MOANALUA FREEWAY, HIGHWAY LIGHTING IMPROVEMENTS
Halawa to H-3 Freeway Underpass
FAP NO. NH-H201(006)

STATE OF HAWAII
DEPARTMENT OF TRANSPORTATION
HIGHWAYS DIVISION
H-201 LIGHTING PLAN
STA. 144+00 TO 154+00
MOANALUA FREEWAY, HIGHWAY LIGHTING IMPROVEMENTS
Halawa to H-3 Freeway Underpass
FAP NO. NH-H201(006)
Scale: 1" = 40'-0" Date: July 2020
SHEET No. E-4 OF 29 SHEETS

"AS-BUILT"

H-201 LIGHTING PLAN-3
Scale 1"=40'-0"

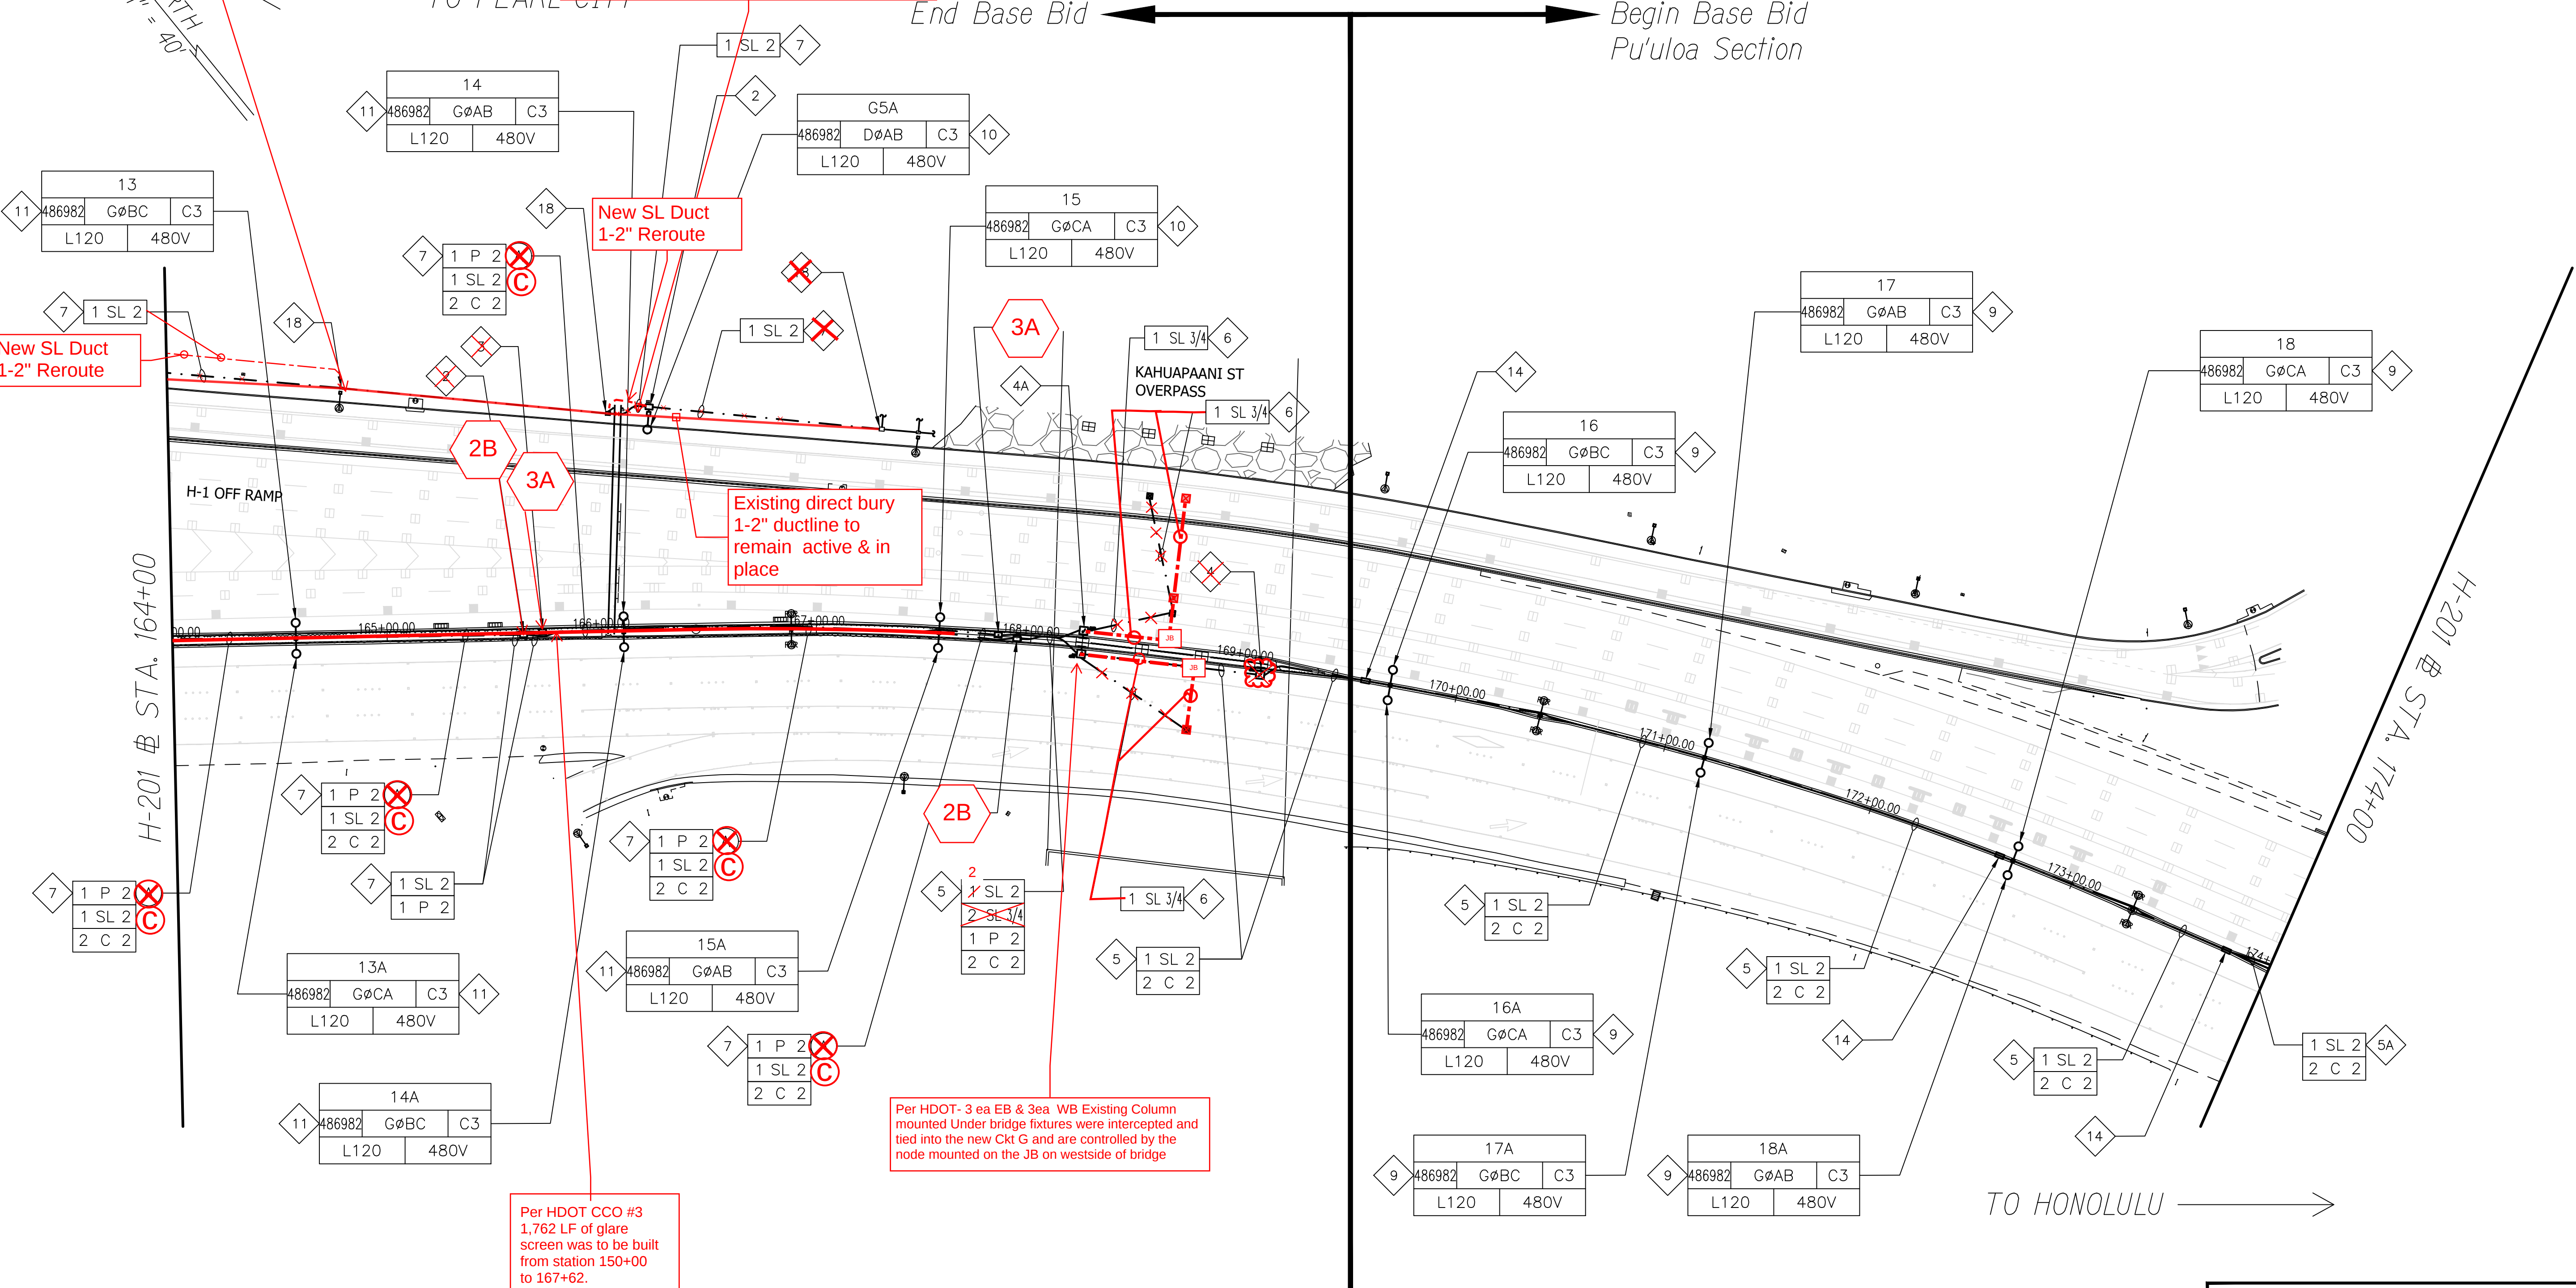
RFI 032:
FDR "D" Splice Into Ckt D at existng pullbox and new duct-line rerouted from exst pullbox and dead ends @ LP G4A

RFI 032:
FDR "D" Splice Into Ckt D at existng pullbox and new duct-line rerouted from exst pullbox and dead ends @ LP G5A
